**CALIFORNIA REGIONAL WATER QUALITY CONTROL BOARD
SAN DIEGO REGION**

**INFORMATION SHEET
ON
TENTATIVE ADDENDUM NO. 1 TO ORDER NO. R9-2009-0005**

**AN ADDENDUM TO INCORPORATE REQUIREMENTS FOR THE DISCHARGE OF
BRINE AND CLARIFY EXISTING REQUIREMENTS**

**RAMONA MUNICIPAL WATER DISTRICT
SAN VICENTE WASTEWATER TREATMENT PLANT
SAN DIEGO COUNTY**

Figure 2. Diagram of Single Liner System (Ohio State University, 2010)

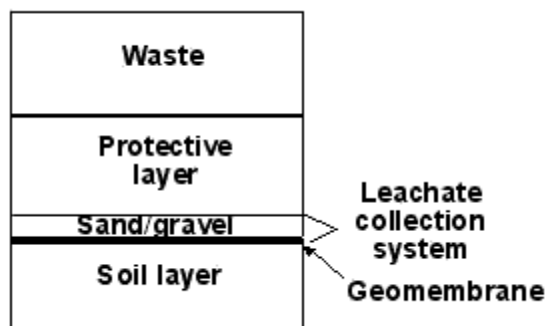
The following outline and figure describe the design for the proposed evaporation pond liner system:

- i. Minimum 4-inch thick gunite layer (primary layer), with finish surface
- ii. Minimum 4-inch thick sand layer (drainage layer)
- iii. Polyvinyl chloride membrane (PVC) (containment layer)

This liner system meets the performance standard of CCR Title 27, section 20330, which states, "Liners shall be designed and constructed to contain the fluid, including landfill gas, waste, and leachate..." Evaporation Pond Facility and Design Specifications ensure protection against water quality impairment. For example, Specification H.7.c requires the subgrade to contain no stones greater than 0.5 inch in diameter, organics, or other deleterious material to prevent tears to the containment layer.

Figure 3. Diagram of Pond Section (RBF Consulting, 2009)

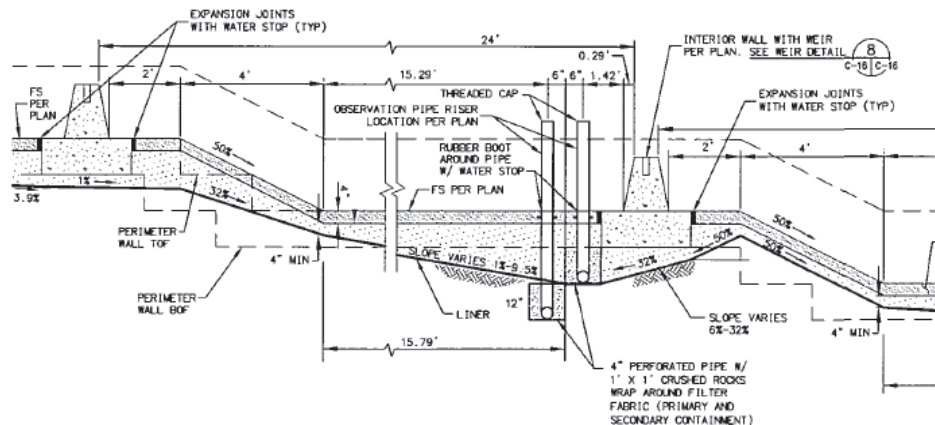
The leachate collection and recovery system (LCRS) is designed in compliance with the prescriptive standards in CCR Title 27 section 20340. The drainage layer, containment layer, and observation ports function as the LCRS. The primary and containment liners will be separated by a minimum of 4 inches of sand. The PVC liner will extend to the edge of the outer edges of the perimeter walls and be sloped towards engineered low points where observation ports will be installed to allow for monitoring of the integrity of the primary layer (Figure 3). Physical evidence of brine accumulated in the observation ports above the containment layer shall be interpreted as a warning that containment of the evaporation pond may be compromised. The observation ports will allow the operator to sample (and remove) any accumulated liquid to determine if the liquid indicates a failure of the primary liner.

Figure 4. SWWTP Wastewater Treatment Schematic

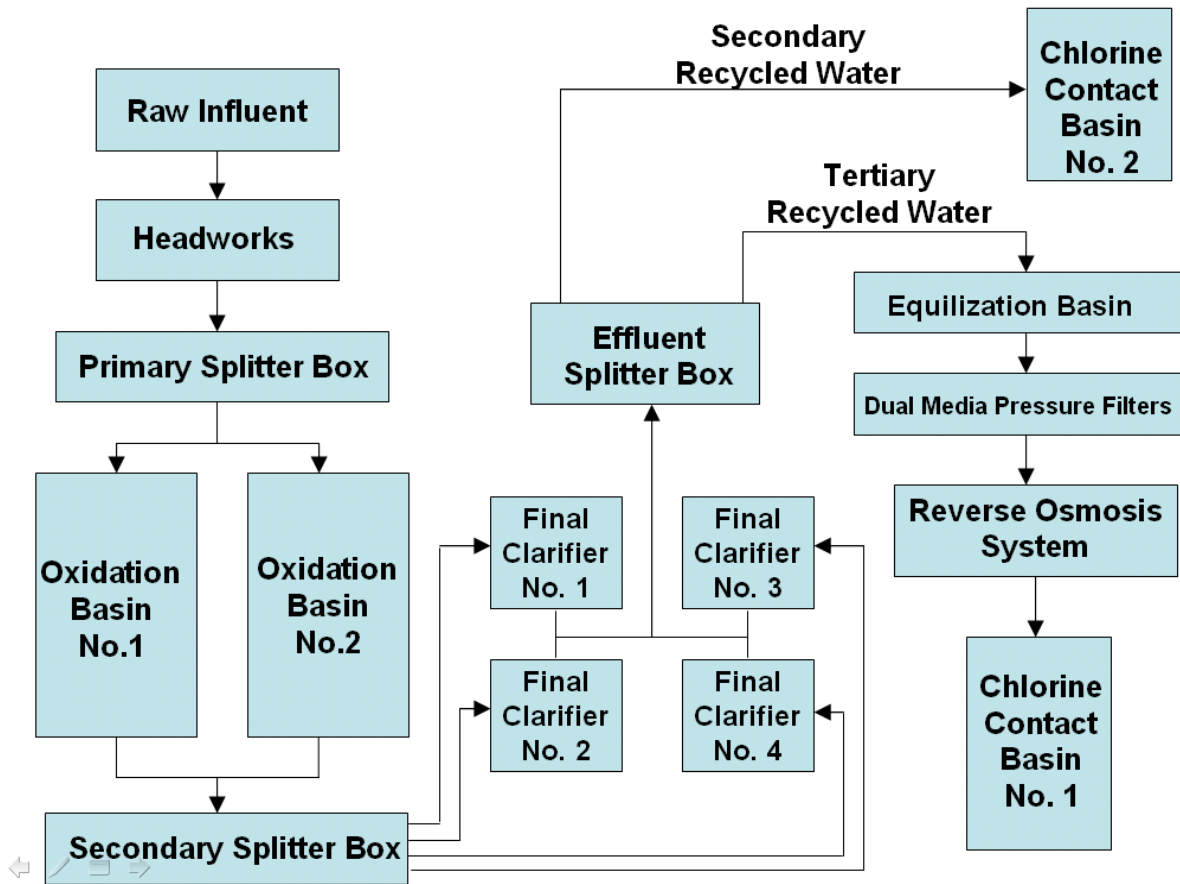
The Ramona Municipal Water District produces both secondary and tertiary recycled water at the SVWTP. Secondary and tertiary recycled water share the same treatment process through secondary treatment at which point secondary recycled water is diverted to its designated chlorine contact basin and tertiary recycled water continues through filtration, reverse osmosis, and disinfection (Figure 4).

Secondary recycled water is delivered solely to Spangler Peak Ranch and tertiary recycled water is delivered to both Spangler Peak Ranch and the golf course located in the San Diego Country Estates. As Monitoring and Reporting Program No. R9-2009-0005 currently reads, both secondary and tertiary recycled water must comply with Discharge Specification B.3.b of Order No. R9-2009-0005 established at 550 milligrams per liter (mg/L); however, secondary recycled water is not treated with reverse osmosis and violates the total dissolved solids (TDS) discharge specification. Secondary recycled water has a TDS concentration of 873 mg/L. Tertiary recycled water has a TDS concentration of 473 mg/L. The Recycled Water Agency produces enough tertiary recycled water to reduce TDS concentrations in the blended effluent to 529 mg/L. (Ramona Municipal Water District, 2010)

The Recycled Water Agency expressed confusion to the San Diego Water Board while trying to implement Monitoring and Reporting Program No. R9-2009-0005 and while assessing compliance. The tentative Addendum, therefore, proposes to clarify that compliance from the SWWTP is based on the blended effluent quality. This is appropriate because both tertiary and secondary recycled water are discharged to the Gower Hydrologic Sub-Area.
